Detail changes for "Mobile Model-SR25502001 Manual"

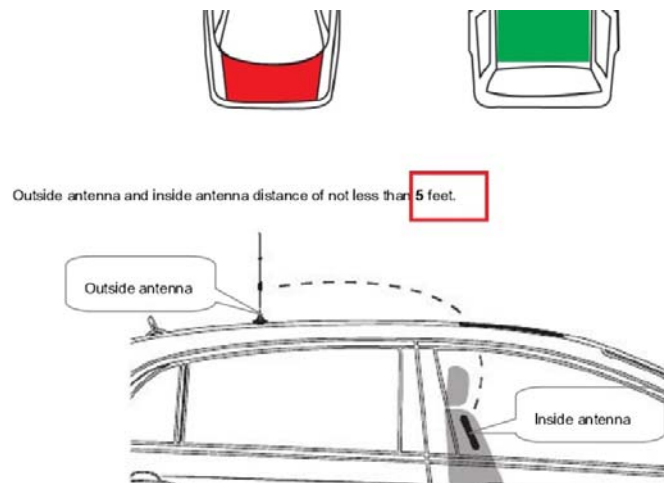
Change 1:

Change outside antenna and inside antenna distance from 15feet to 5feet.
